Subject: Modification of the Approved Groundwater Remedy for the Plant Site at the Colstrip Steam Electric Station in Colstrip, Montana

Geosyntec Consultants, Inc. (Geosyntec) on behalf of Talen Montana, LLC (Talen Montana) has prepared this letter to request a modification of the approved groundwater remedy for the Plant Site at the Colstrip Steam Electric Station (CSES) in Colstrip, Montana.

DATE: June 29, 2023 **PROJECT NO.** 350.0064.005
TO: Carrie Pendleton -Geosyntec
CC: Gordon Criswell and Jennifer Petritz – Talen Energy
FROM: Amelia Tallman, Derek Goble - NewFields
SUBJECT: Plant Site Closure Remedy Modification Modeling

**Alternative B - Closure by Removal to new
Plant Site Disposal Units
Plant Site Closure Options Modeling
CSES-Colstrip, Montana
FIGURE 1**

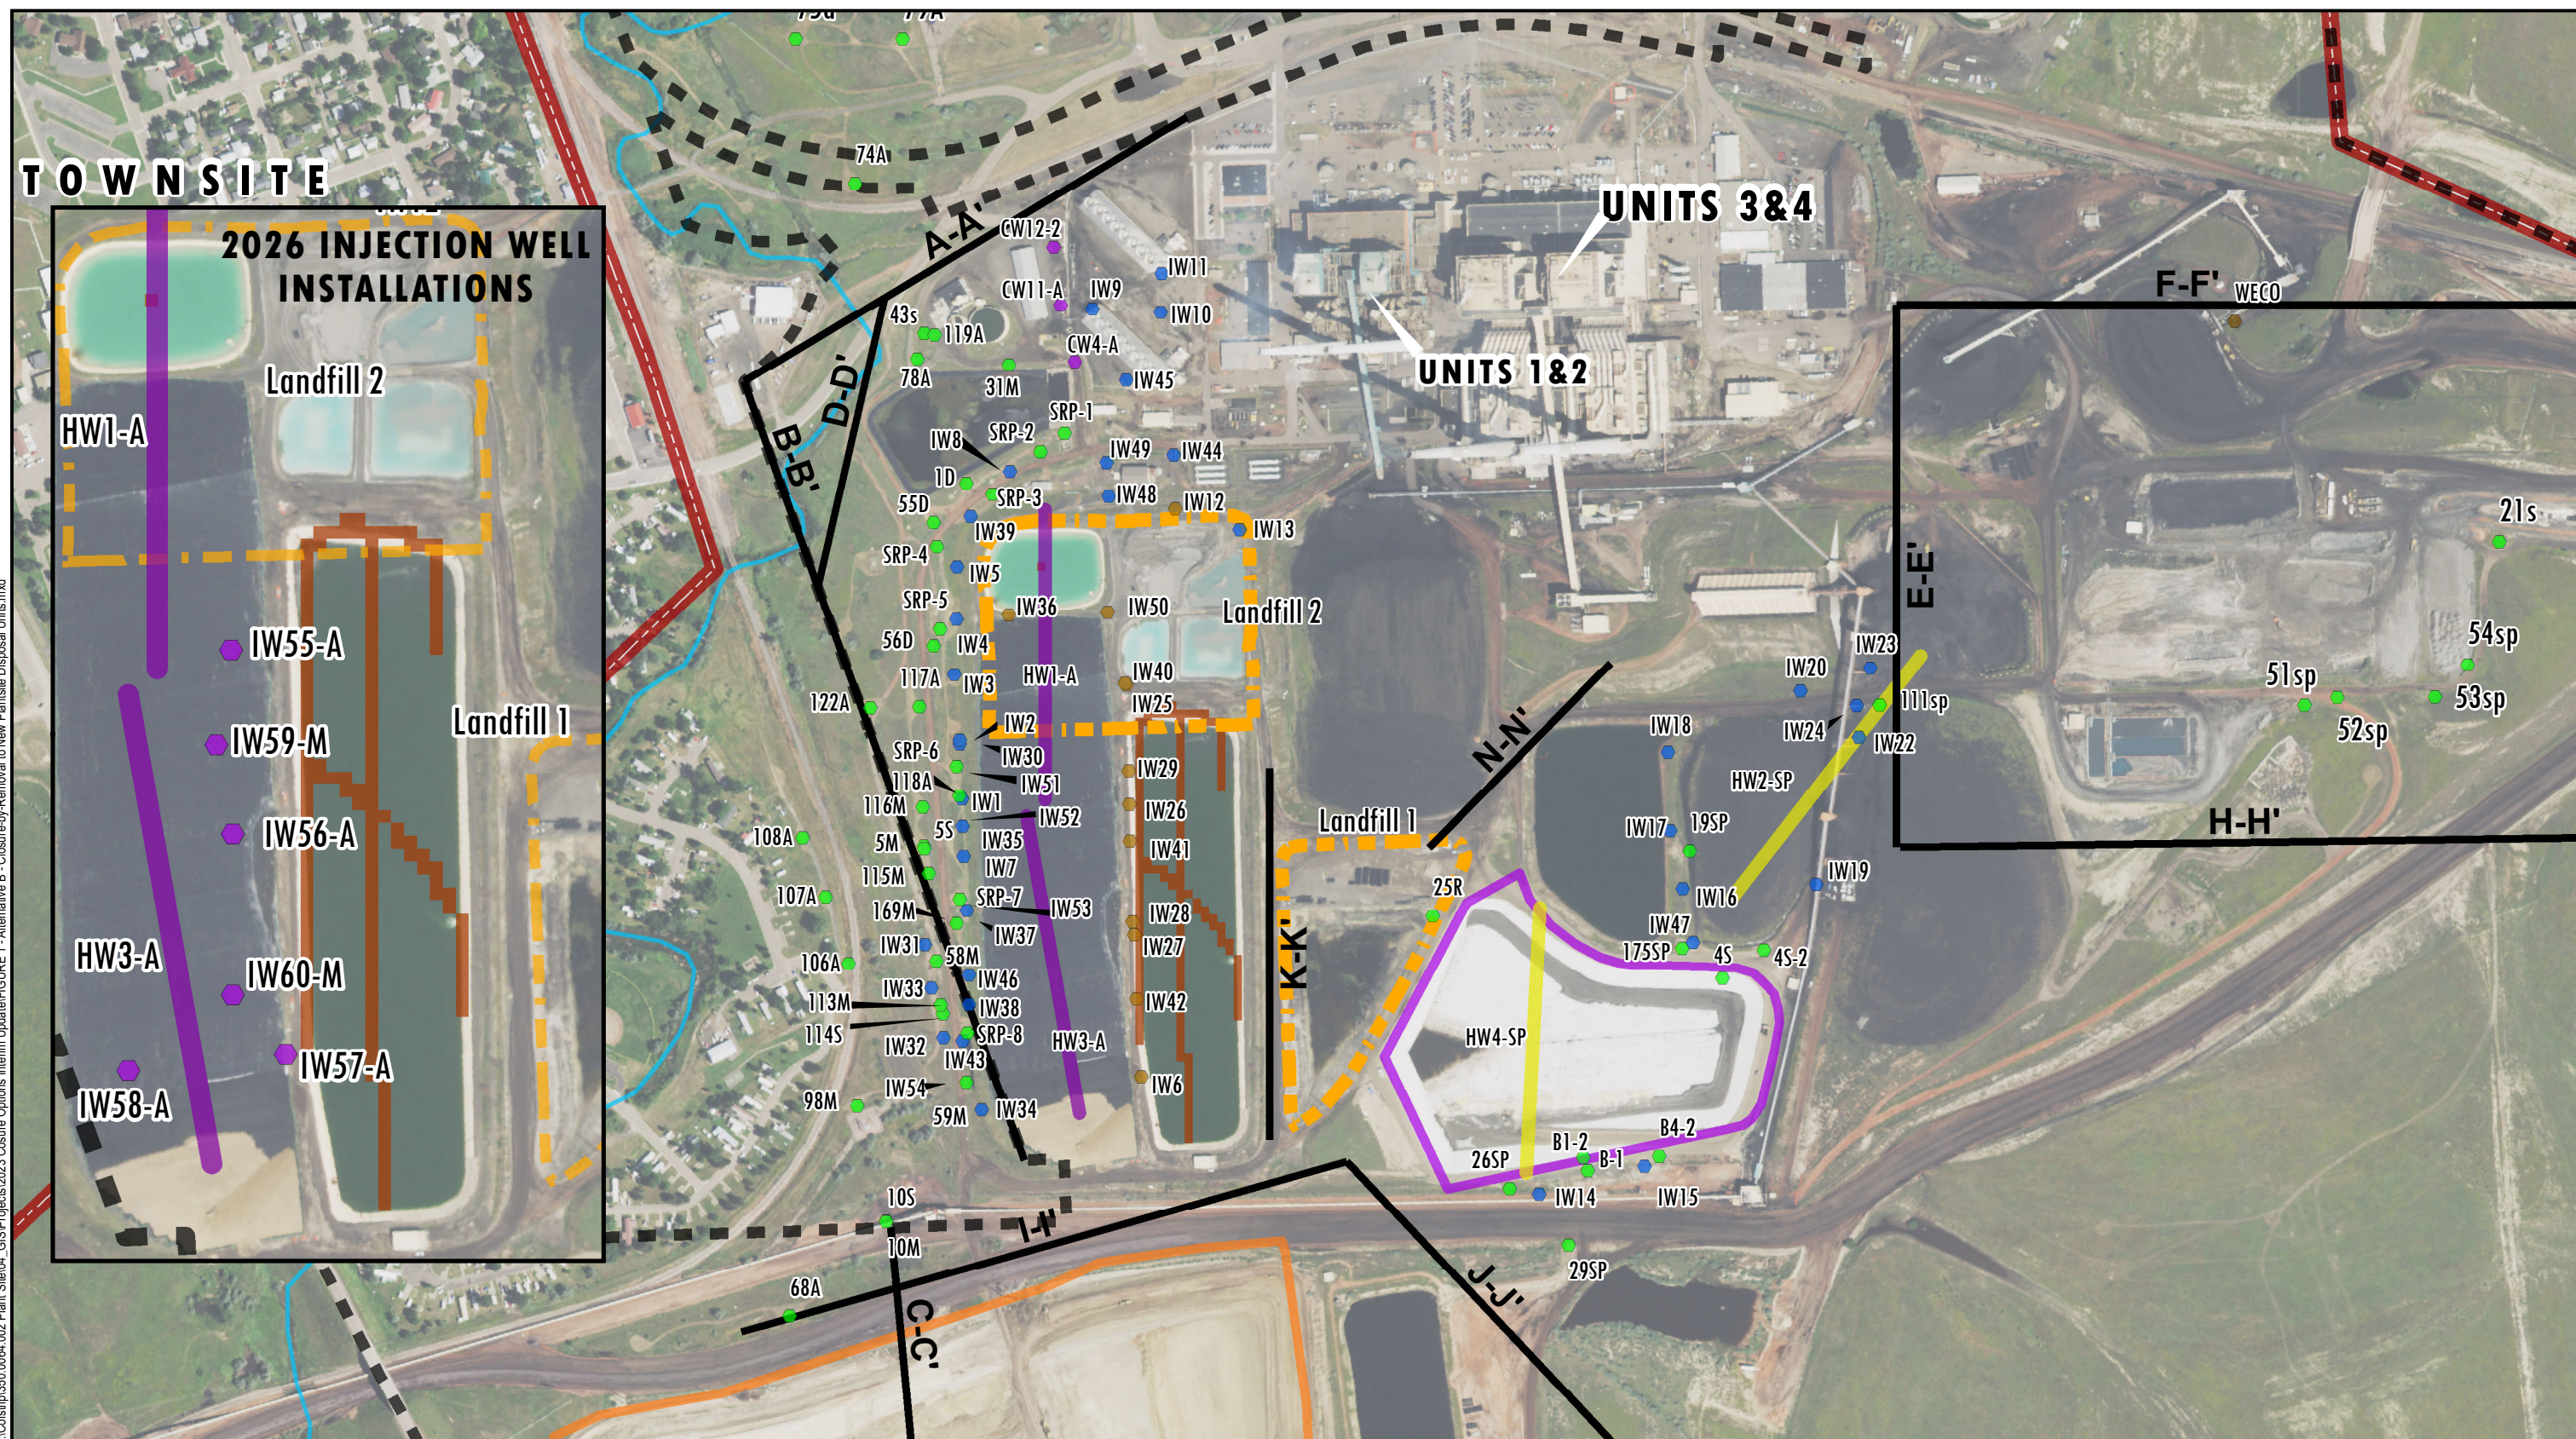
This Alternative includes the construction of two new disposal sites on the Plant Site property, adjacent to A and B Ponds (**Figure 1**). Landfill #1, located east of B pond, would be constructed in 2024 and include disposal of ash from the 1&2 Bottom Ash Ponds. Landfill #2, located in the footprint of the former 1&2 Bottom Ash Ponds, would be constructed in 2025 and include disposal of ash from A Pond and B Pond. After excavation, the surface of A and B Ponds would be graded with fill material to prevent ponded water and would receive background recharge.

Construction activities and ash removal would impact existing remedy injection wells. Wells IW-6S, IW-12M, IW-25, IW-26M, IW-27M, IW-28A, IW-29A, IW-36M, IW-40A, IW-41A, IW-42A, and IW-50A would be decommissioned in 2024 to prevent interference with construction and ash removal activities. During this time the B Pond underdrain and horizontal capture wells under A Pond would remain active. After both landfills are closed and A and B Pond surfaces have been reclaimed to prevent ponding, five new injection wells would be installed to replace the decommissioned wells and resume flushing activities. In 2026, IW55-

A, IW56-A, IW57-A, and IW58-A would be installed in shallow groundwater system, and IW59-M and IW60-M in the McKay, to promote additional flushing of constituents under A and B ponds (**Figure 1- inset**).

Hydrographs of Water Levels Below Landfills
Plant Site Closure Options Modeling
CSES-Colstrip, Montana
FIGURE 2

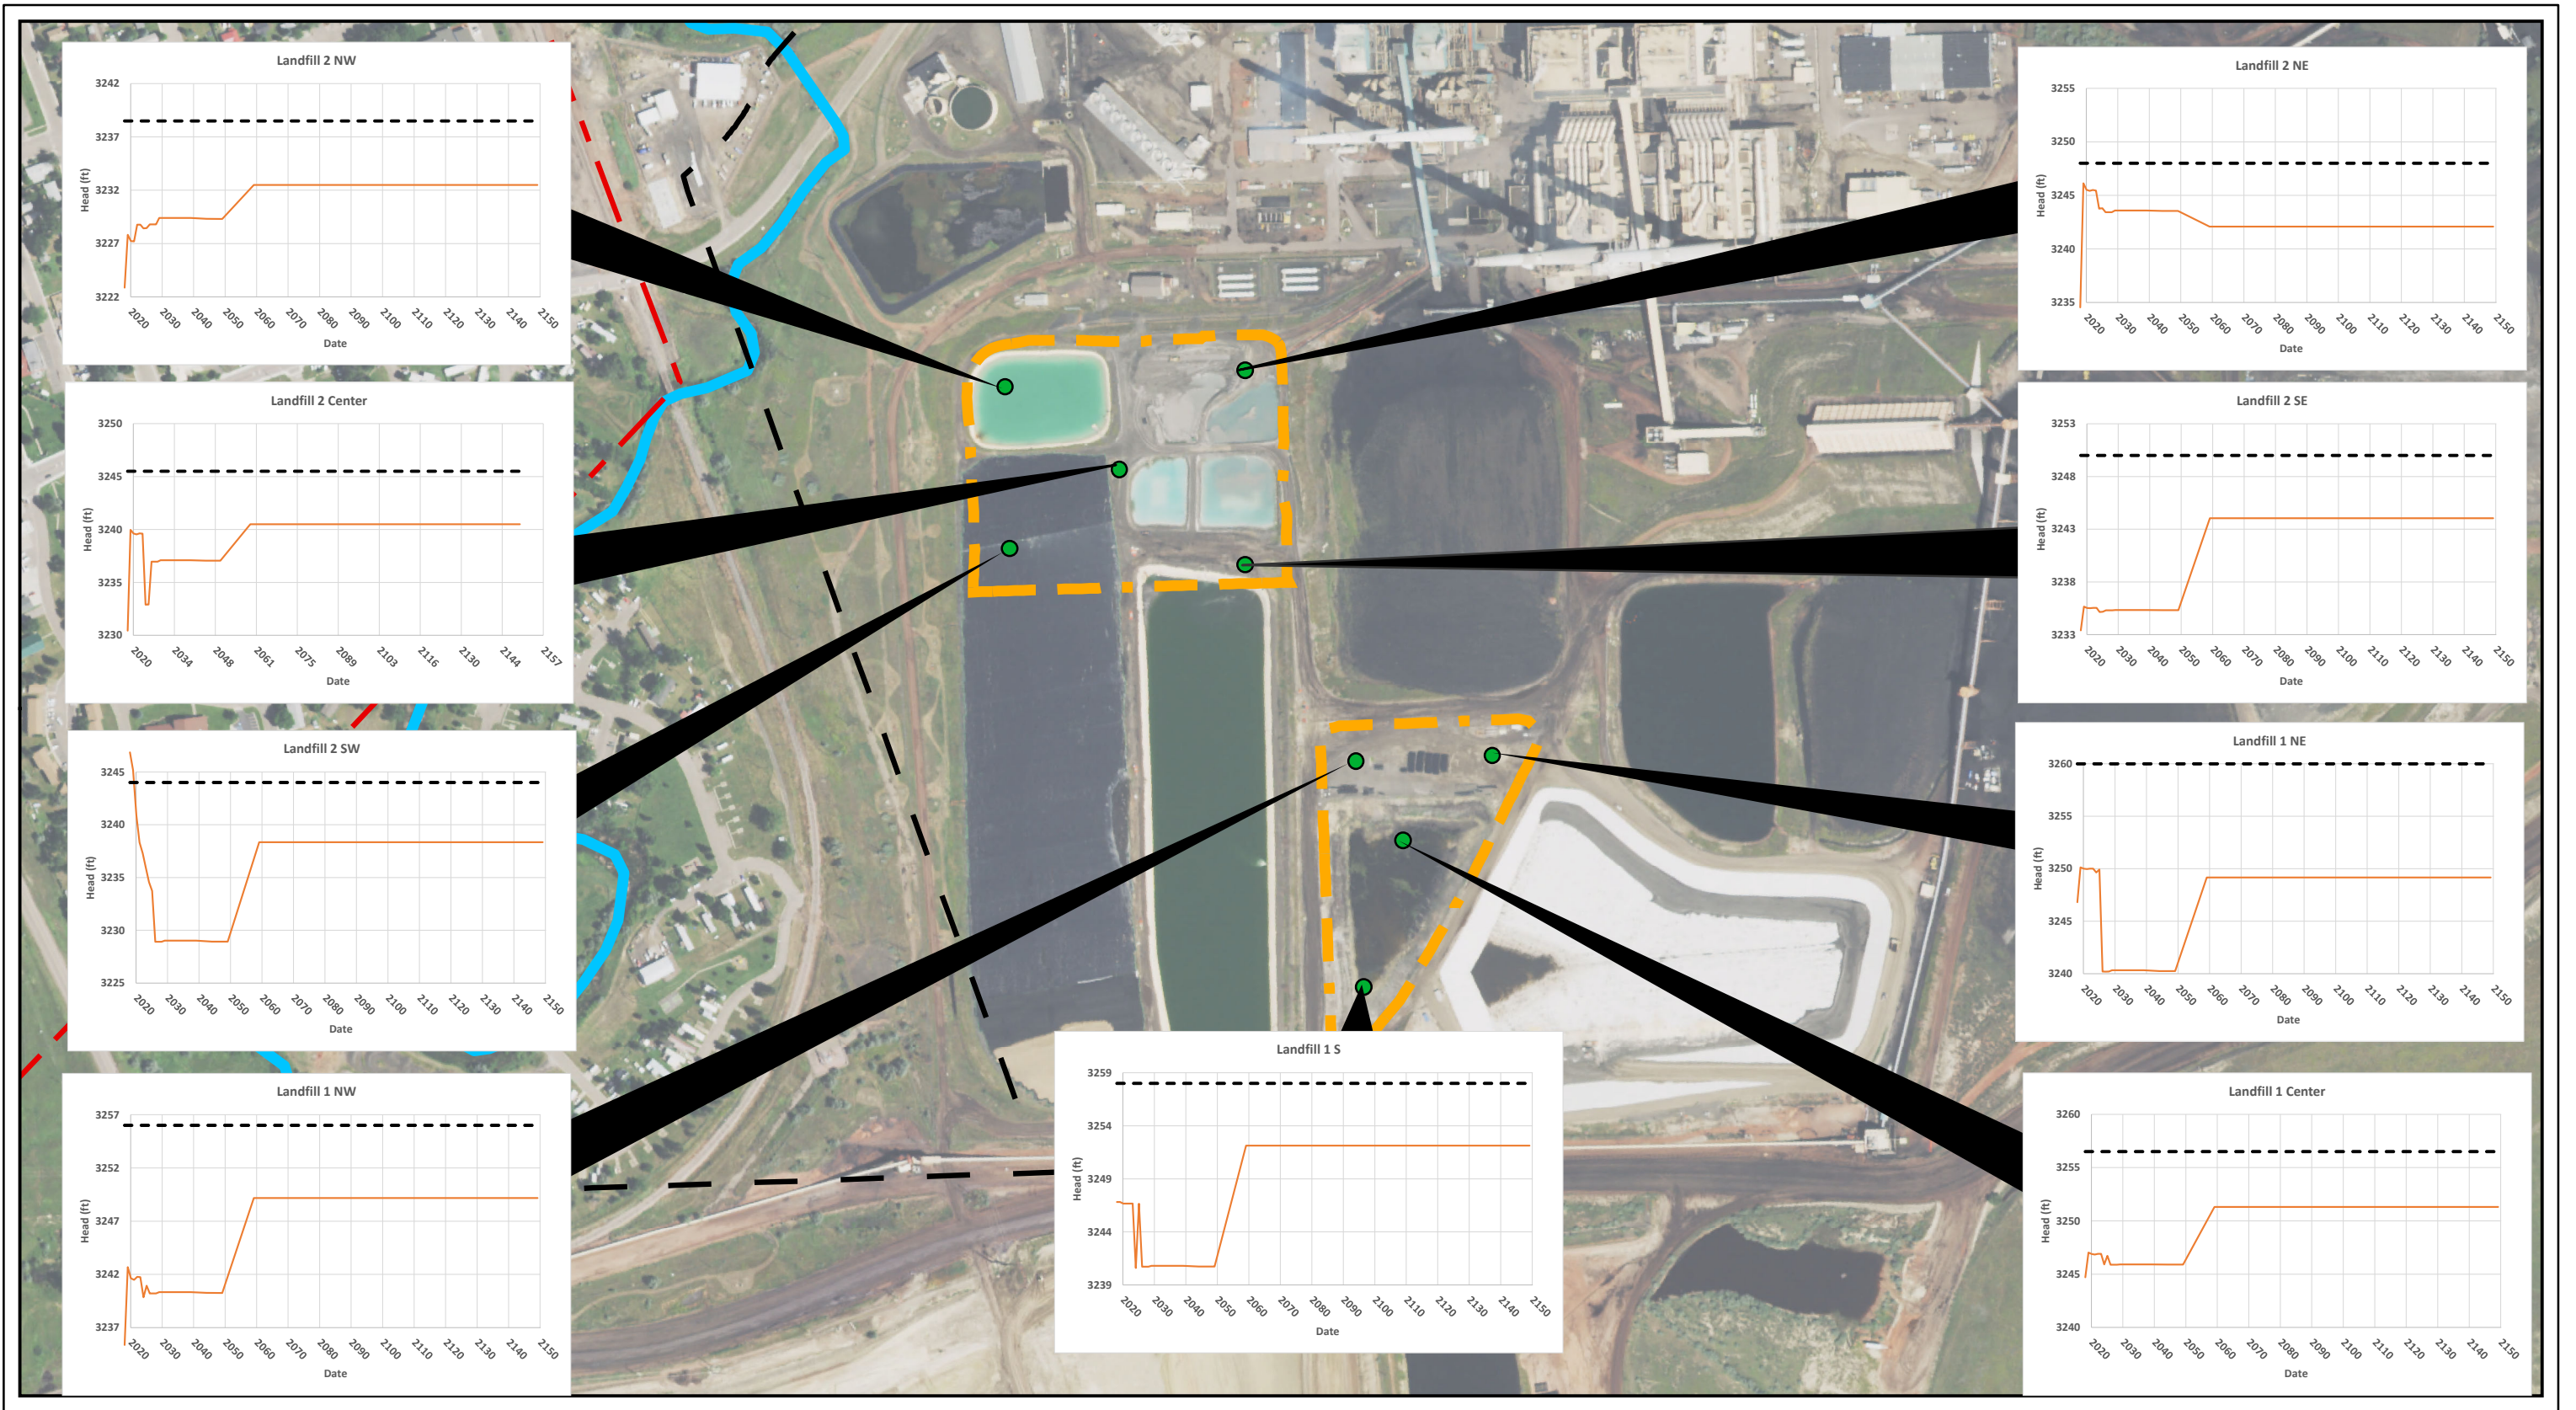
Figure 2 contains hydrographs at hypothetical monitoring points under the new ash disposal units to illustrate the simulated water table in relation to the bottom of the lined landfills. A 5-foot separation is maintained at all the landfill points throughout the simulation.
